LOCATION OAKVILLE CREEK BRIDGE

SLOPE EROSION - WEST END

MINUTES OF MEETING

RE: Erosion, West End, Oakville Creek Bridge
W.P. 205-~~63~~-01, Site 10

- (1) Elevation of ditch liner.
- (2) Details of gabions.
- (3) Detail of ditch liner anchorage into rock.
- (4) Portion of D-4.
- (5) Gabion S.P.

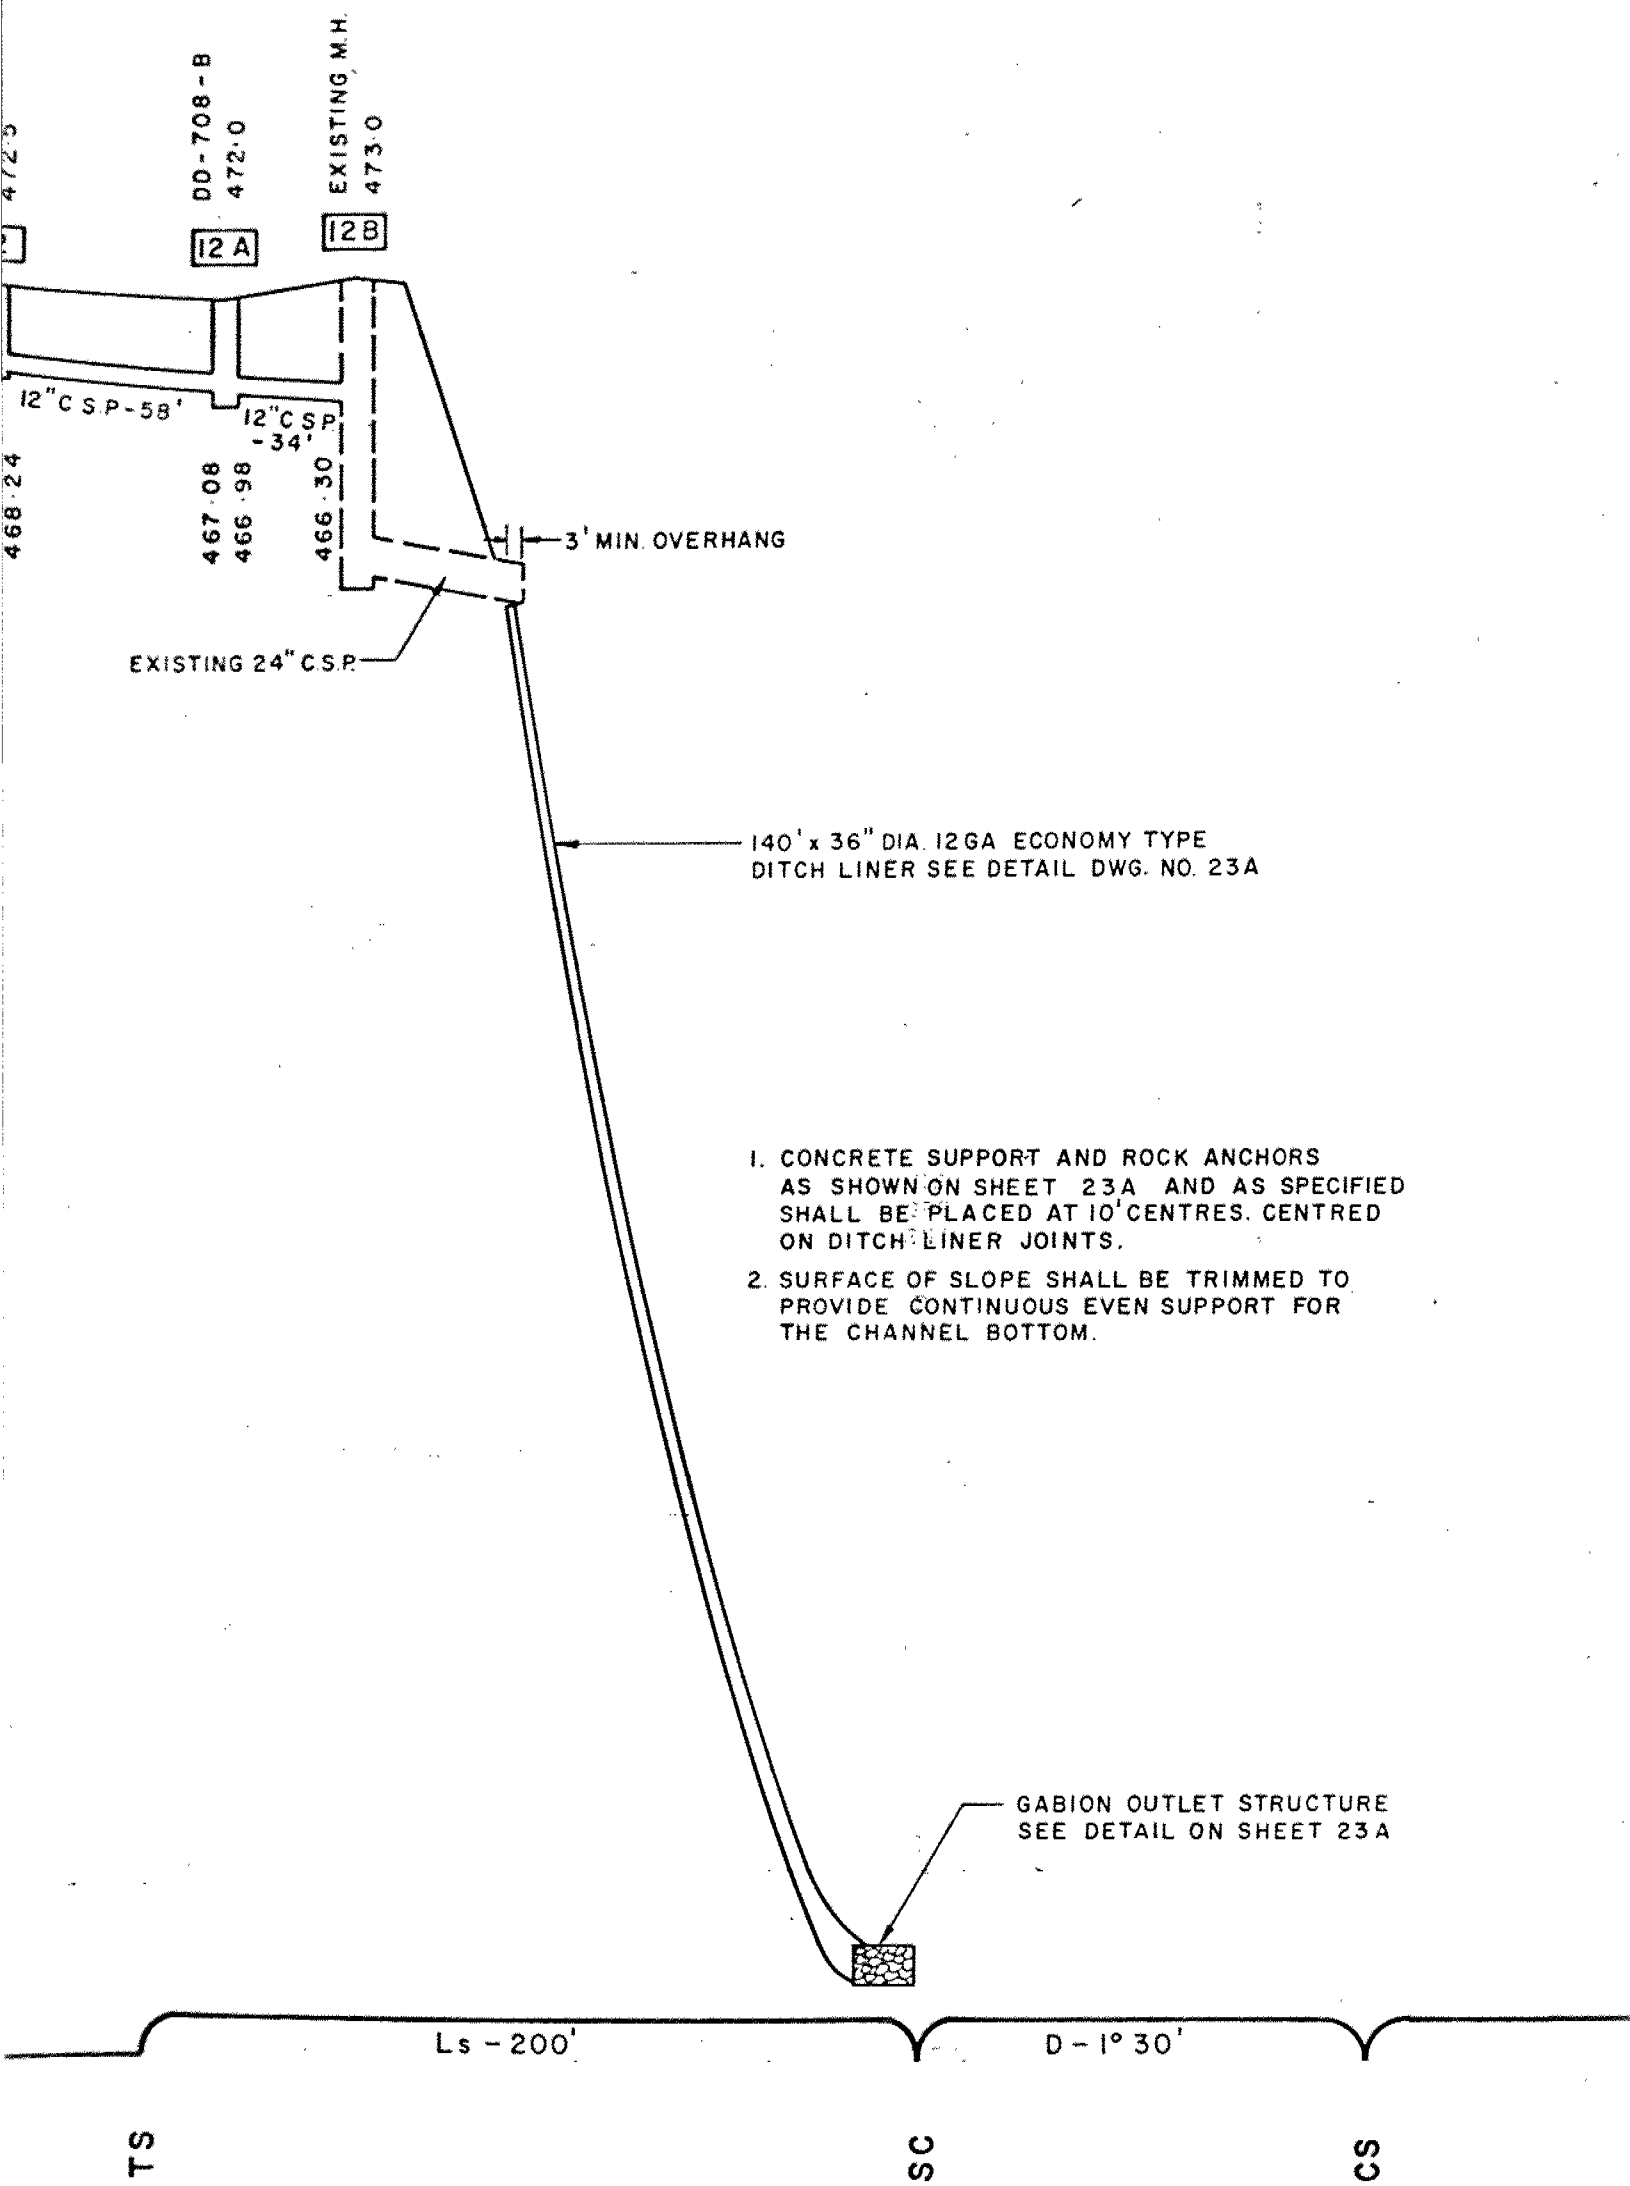
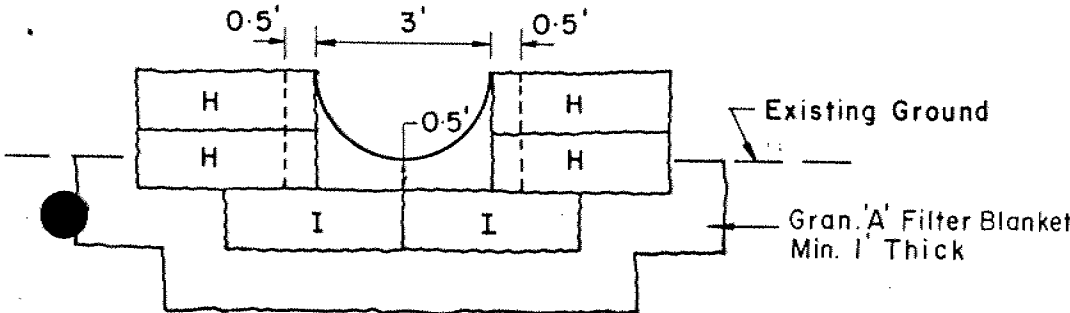
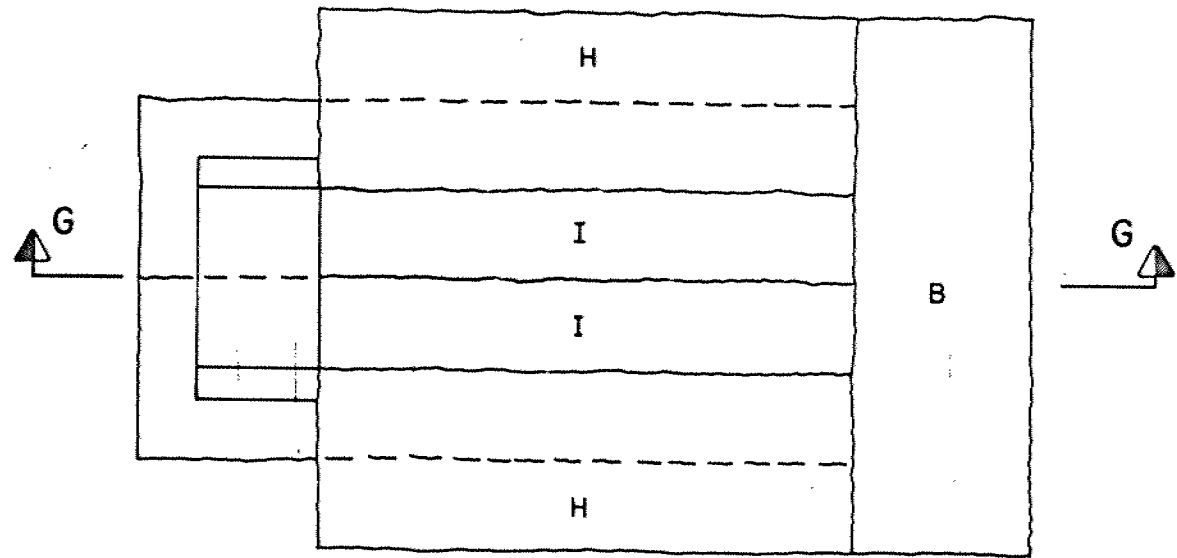
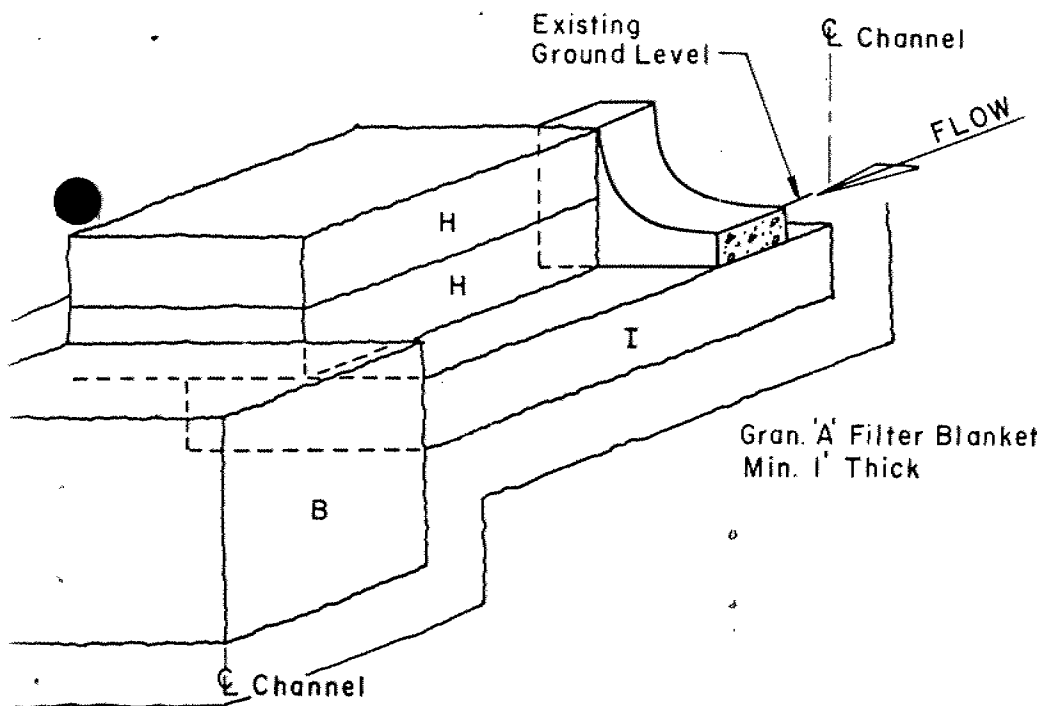
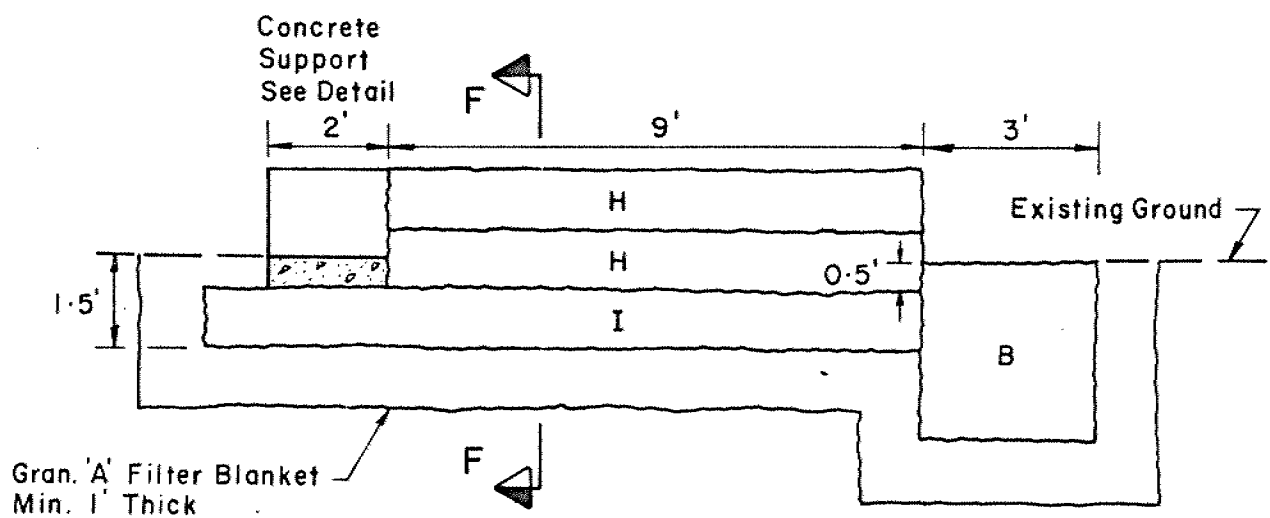
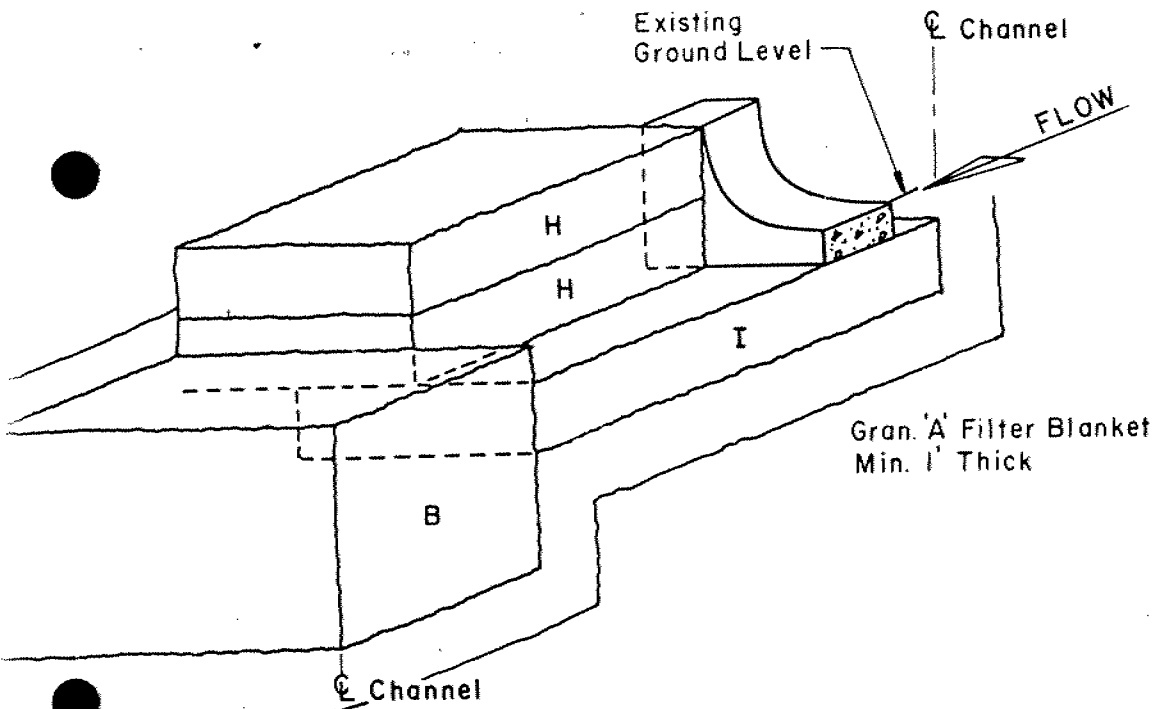
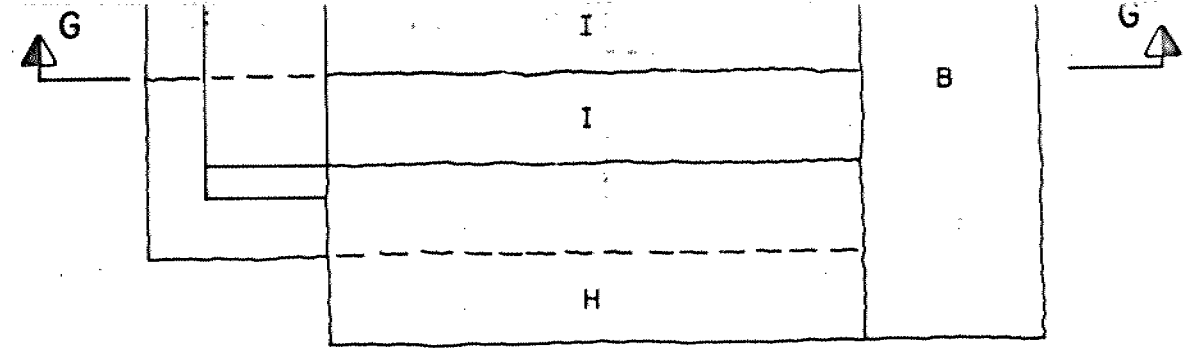
1. B. Ly reviewed the proposed drainage improvement details and agreed that the proposals will largely eliminate erosion caused by the present 24" C.S.P. but noted that erosion will continue due to surface run off from the slopes.
2. The rock anchor lengths should be increased in length from 6 ft. to 10 ft.
3. An elbow should be provided at the end of the 24" C.S.P. to direct water into the ditch lines.
4. D. Riseboro will check with Remote Sensing to establish whether photography is available at different times for this location. It may be possible to establish rates of erosion from such photography.
5. B. Ly and D. Riseboro will visit the site on May 18, to establish a method of monitoring the slope.
